**ITEM #1:** **CASE 20-016 – UPLAND HOMES COUNTRY WALK – SITE PLAN AMENDMENT.**

**TITLE:** **THE APPLICANT, UPLAND HOMES, IS REQUESTING AN AMENDMENT TO THE APPROVED COUNTRY WALK SITE PLAN FOR REVISED SINGLE-FAMILY ARCHITECTURAL ELEVATIONS.**

TO: Van Buren Township Planning Commission  
FROM: Dan Power– Director of Planning and Economic Development  
RE: SPR 20-016 Site Plan Amendment for Upland Homes regarding  
New Architectural Elevations in Country Walk Subdivision  
DATE: May 20, 2021

2100 PLAN

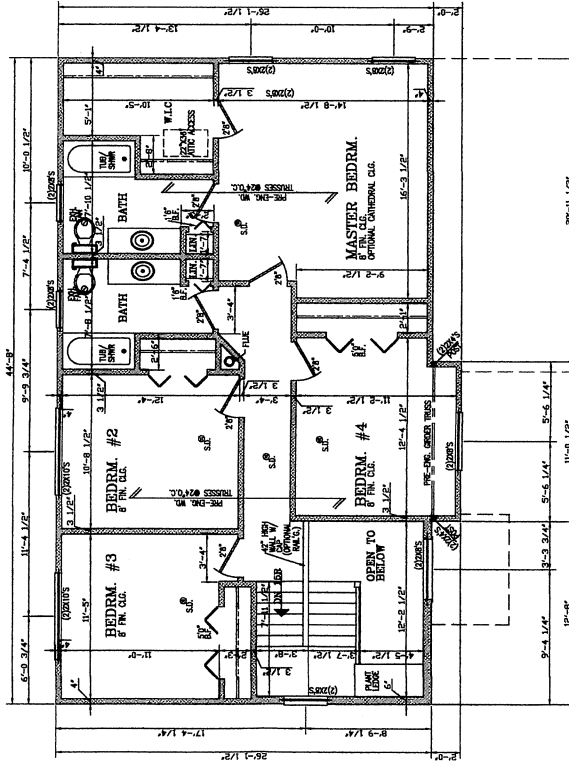
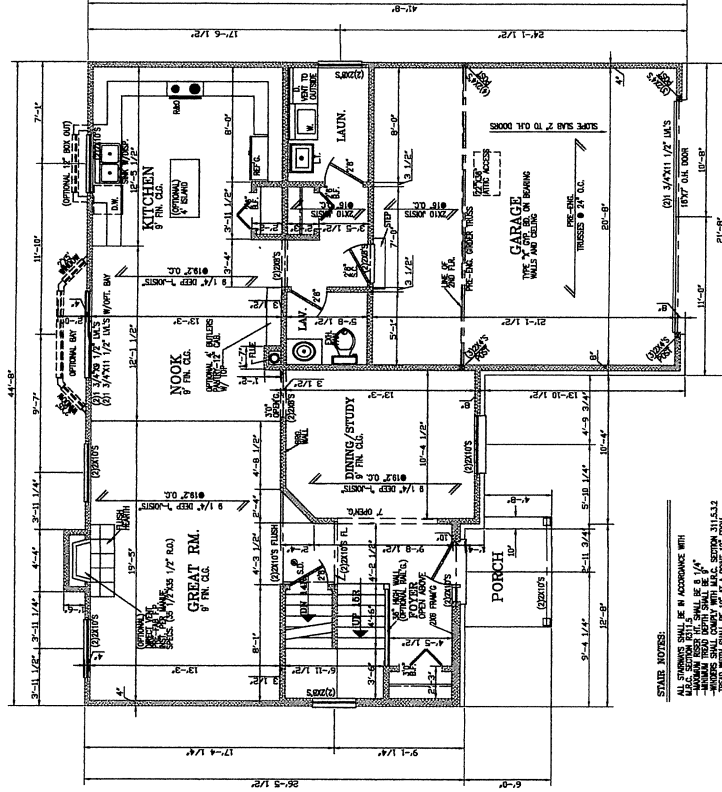
The proposed model dimensions of 44'-8" wide by 41'-8" deep at the furthest extents of the home will fit on any lot greater than 64'-8" wide. Staff will review each application's plot plan to ensure the model will fit within the required 10' side yard setbacks.

The PRD agreement requires that the square footage of homes for the 536 units in the subdivision will average at least 1,750 square feet. The proposed model will have a floor area, not including the garage or basement, of 2,100 square feet. The minimum required floor area will therefore be met.

Section i(1) of the PRD agreement requires that all 416 detached units feature brick to the belt on the front and side elevations and requires that on specific lots brick will be required on the rear elevation as well. The proposed elevation meets this requirement with the significant application of brick on all sides.

The proposed elevations all includes a side-entry garage, so it can contribute to the requirement of 30% of detached units in the PRD having side-entry garages.

Staff recommends that the Planning Commission approve the site plan amendment to the Country Walk development for the addition of the proposed elevations, Plans 2100 A, B, and C, to be built by Upland Homes based on the following condition:

1. Township Planning Staff shall review each application for a new single-family home in the Country Walk development in order to determine that the new home meets the required

setbacks and that the elevation meets the Township's "Substantially Different" architectural design standards set forth in the PRD agreement.

2. Township Planning Staff will evaluate all plot plan submittals for these home models to ensure they meet the minimum required 10' side yard setback.

2100 PIAH - "A"

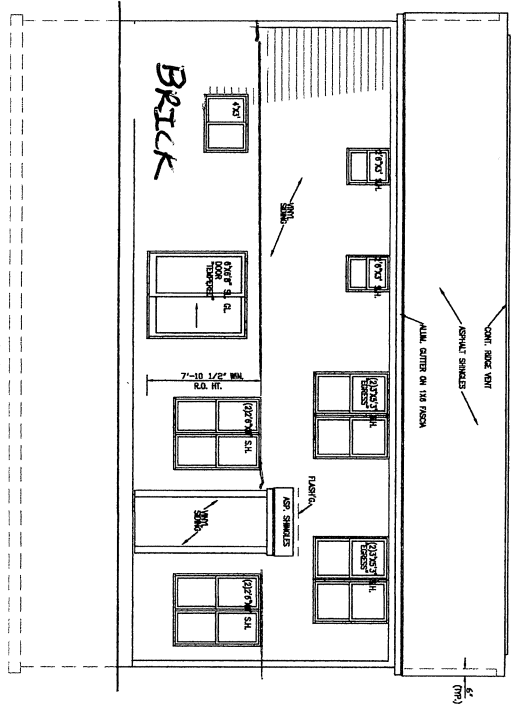
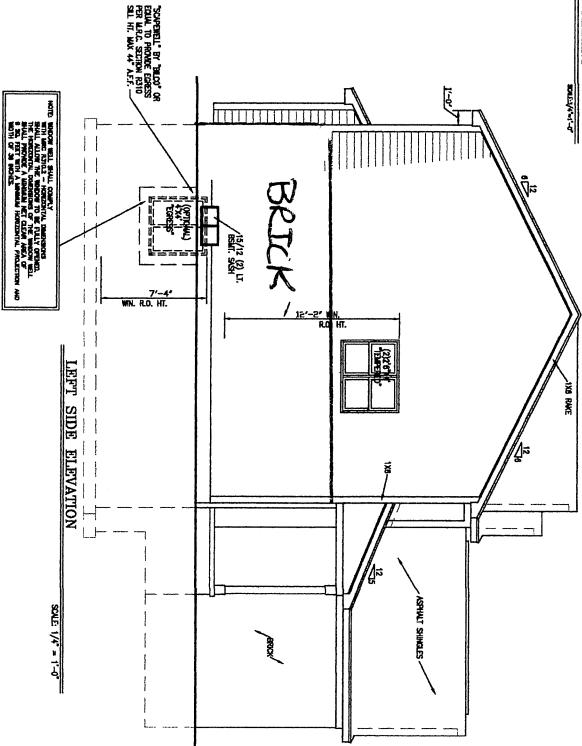
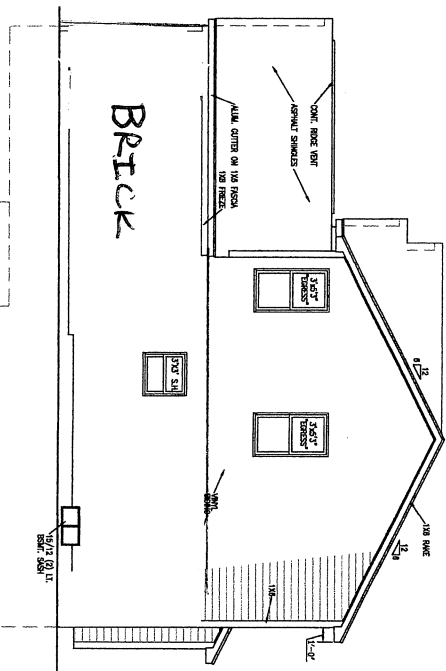
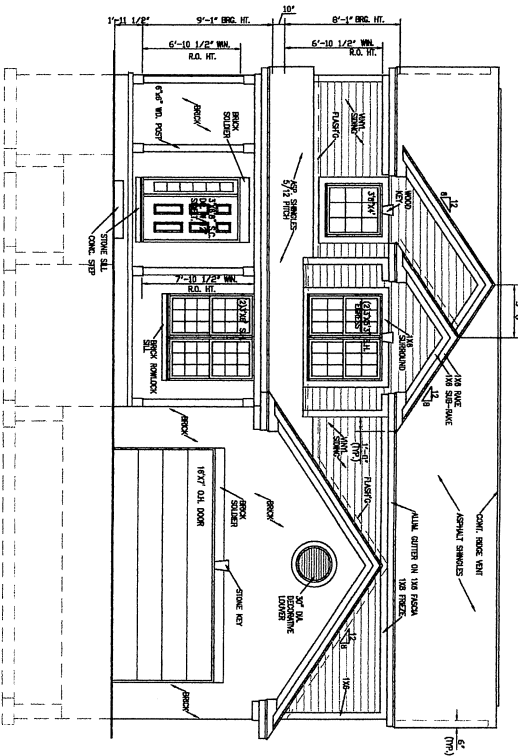
The design of these elevations' roof pitches should be compared to those of the other previously approved elevations. The proposed roof pitch is generally 6/12 for the main gable roof, 8/12 over window rakes and garages, and 5/12 over porches. Roof pitch alone may not distinguish the proposed elevation types from one another. Therefore, the location of major design feature criteria may have to be used in place of the roof pitch requirement.

The applicant has shown in the past that they understand the substantially different requirement and can meet it through the prior submission of combinations of home styles and elevations. With this request, the applicant has demonstrated that they can continue to meet this requirement. I have reviewed the proposed elevations in relation to all other previously approved elevations by this builder in the development. See the attached set of previously approved home models attached to this packet. The 2159 and 2320 models and the proposed model have several similarities including the location of the main entry door relative to the mass of the structure and the use of a Colonial floor plan. However, the proposed model variations are wider than the other Colonial models. The width as well as other attributes of the proposed model are adequate to demonstrate substantial difference between the proposed model variations and all models that were previously approved.

Roof style	Roof pitch	# of windows (front)	Door relation to mass	Design feature and relation to mass	Materials observations
<b>2100 (A)</b>	Gable	6/12 (main)	3	Opposite garage	1. Rake on center upper window 2. Short porch roof	1. Horizontal siding on garage 2. Full vertical brick banding on garage sides
<b>2100 (B)</b>	Gable	6/12 (main)	3	Opposite garage	1. Double rake on upper windows 2. Medium-length porch roof	1. Extended horizontal siding on garage 2. Limited vertical brick banding on garage sides
<b>2100 (C)</b>	Gable	6/12 (main)	3	Opposite garage	1. Double rake on upper windows 2. Full-length porch roof	1. Full brick garage
